RE: Whitewood Creek Restoration, Deadwood SD
Sites 1C, 2A, 2B, 3A, & 3B
Cost Proposal #05 – Proposal Request No. 5 (January 23, 2024)

REQUEST FOR PROPOSAL

Whitewood Creek Restoration – BP #1

PROPOSAL REQUEST NO: 5

Albertson Engineering Inc.
 3202 W. MAIN, SUITE C
 RAPID CITY, SD 57702
 605.343.9606

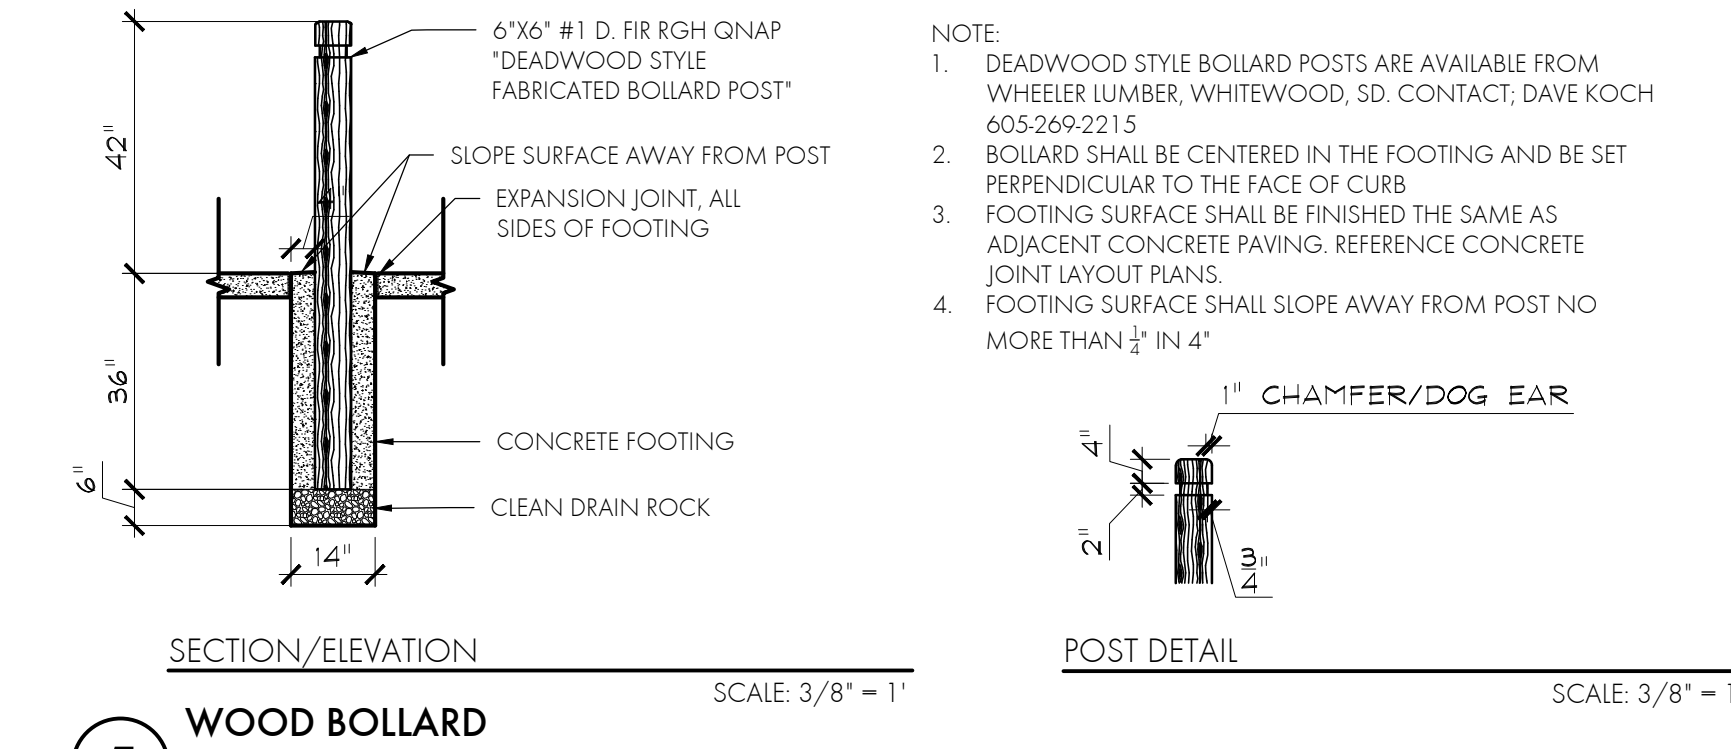
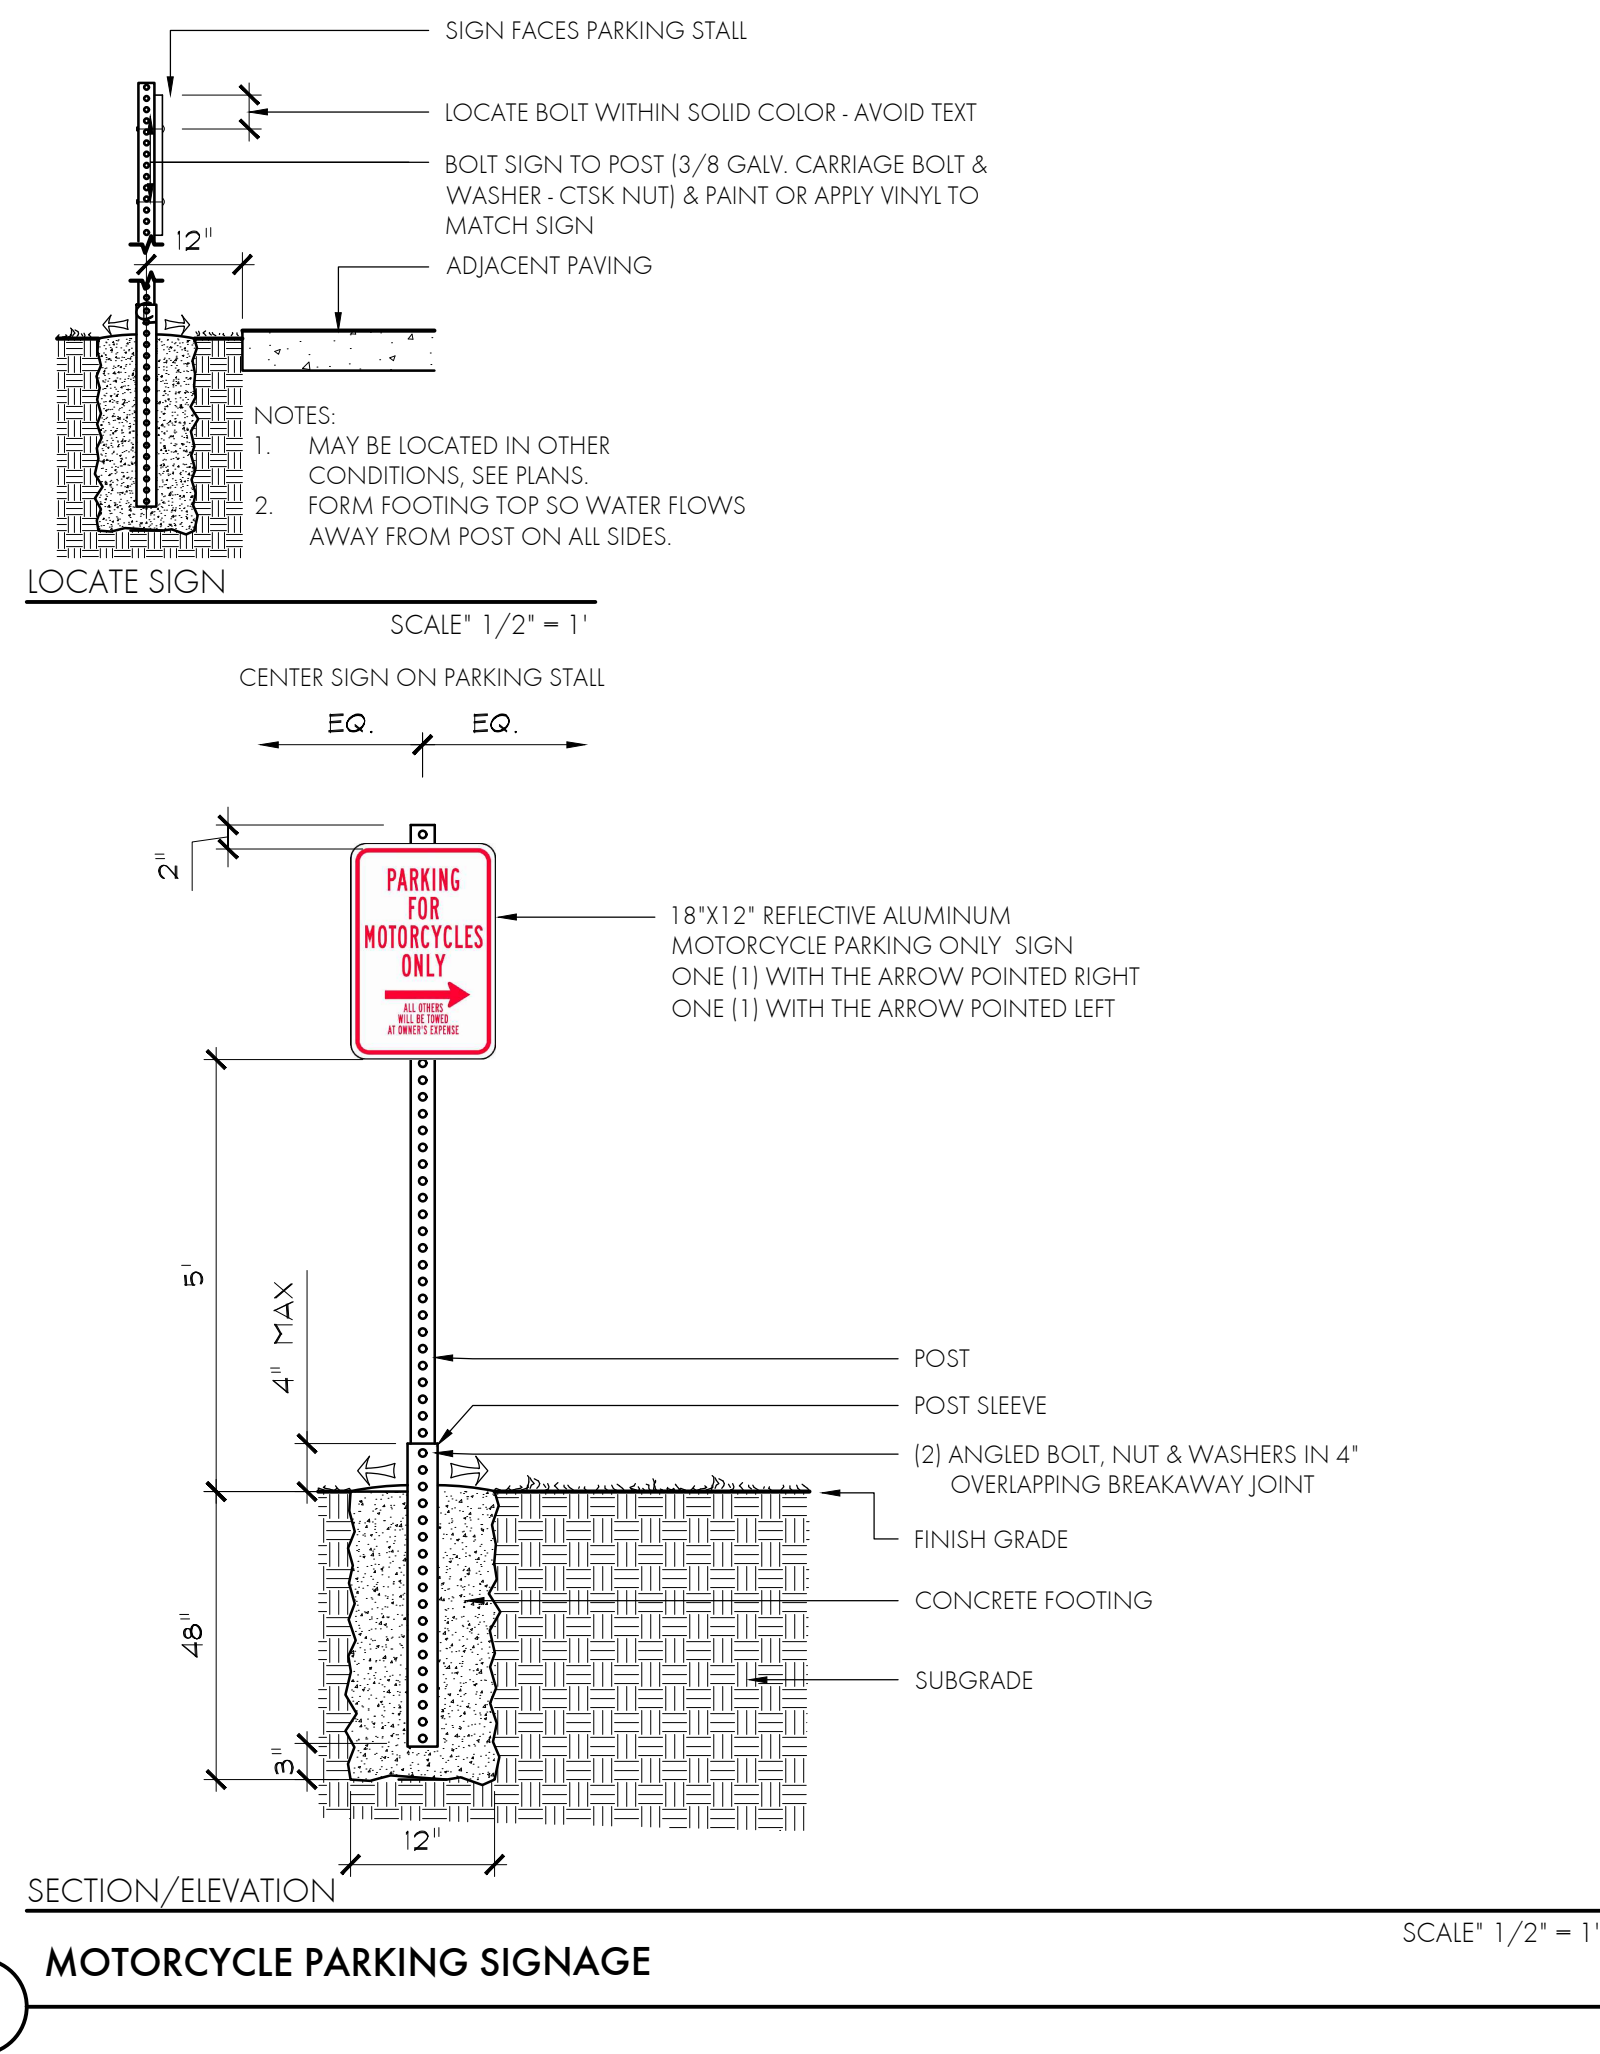
Supplemental Instruction to clarify that two (2) lag screws are required per fence rail to attach to post, consistent with the Section/Elevation in detail 4 sheet L-304. Also, stagger rail joints each row such that a fence post either has (14) or (16) total fasteners.
